MEMORANDUM

Date: December 1, 2021
To: Chief Administrative Officer
From: James van Hemert
Re: Application for a Development Permit for 42 Savoy, Lot 16,
Block 7, Section 5, Renfrew District (Situating in Cowichan Lake District), Plan
1750, PID: 000-057-401

The applicant requests a Development Permit to support the construction of a single-detached residence.

Figure 2 Front (north) elevation

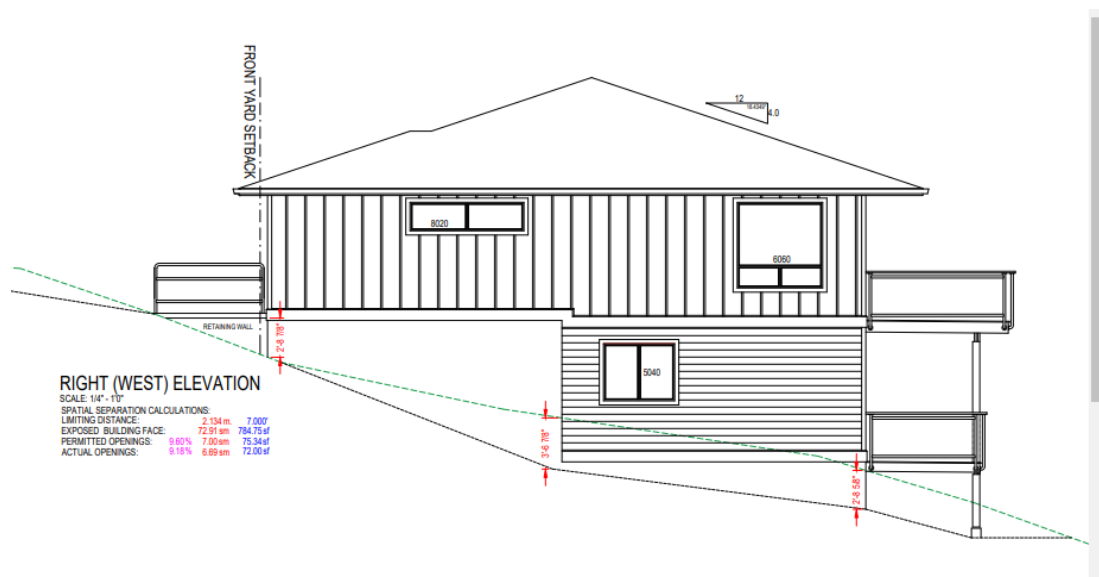
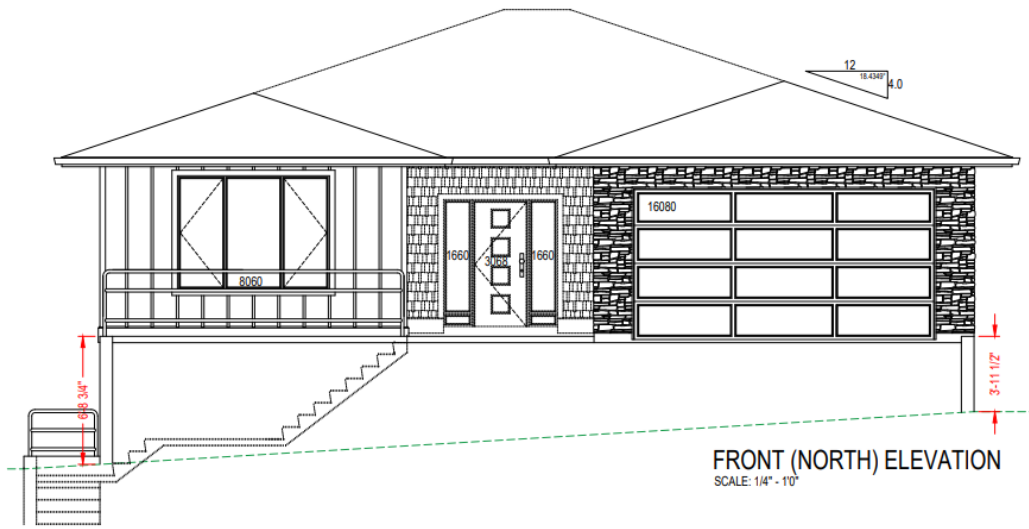
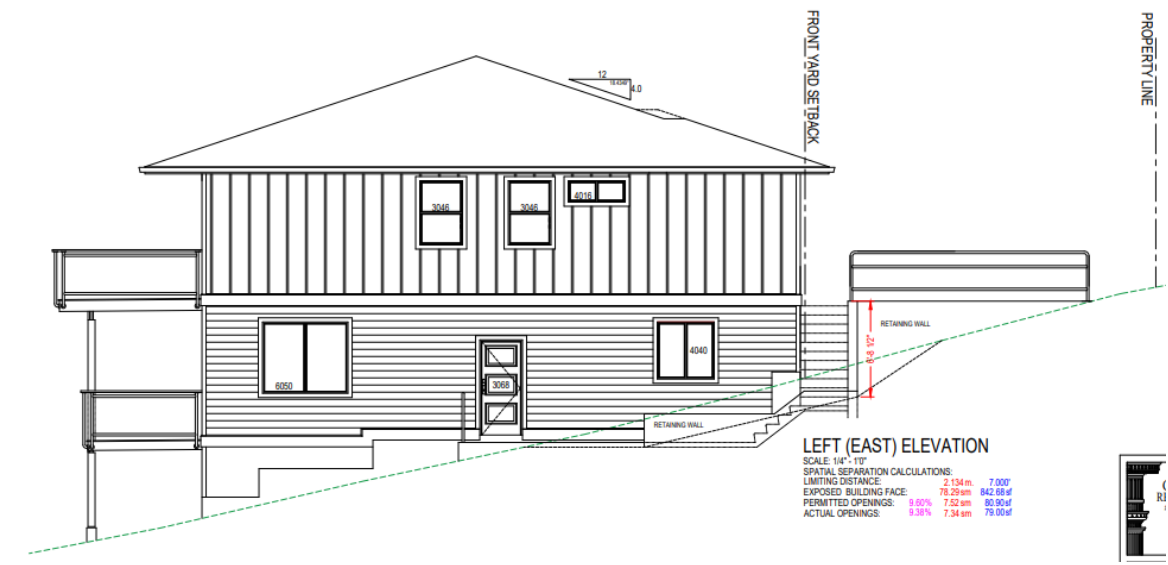
The front and side elevations (also see below) identify the use of retaining walls along the left and right sides of the driveway. The house was dropped a metre in elevation from the roadway to accommodate the slope and avoid extensively high foundation walls and retaining walls.

Prior to receiving a building permit, a geotechnical assessment must be completed. Standard perimeter drainage in accordance with the BC Building Code will be required. It will inform foundation design and site drainage. Additional dewatering facilities such as a rock pit shall be determined at the time of building permit review.

- 1) A geotechnical assessment shall be completed to the satisfaction of the Town's building inspector prior to issuance of a building permit.
- 2) No retaining walls over 2.0 metres in height shall be permitted.
- 3) Prior to the issuance of a building permit, any retaining walls, and structures higher than 1.0 metres must be designed by a professional geoscientist or structural engineer to the satisfaction of the town's building inspector and must be located entirely on the parcel.
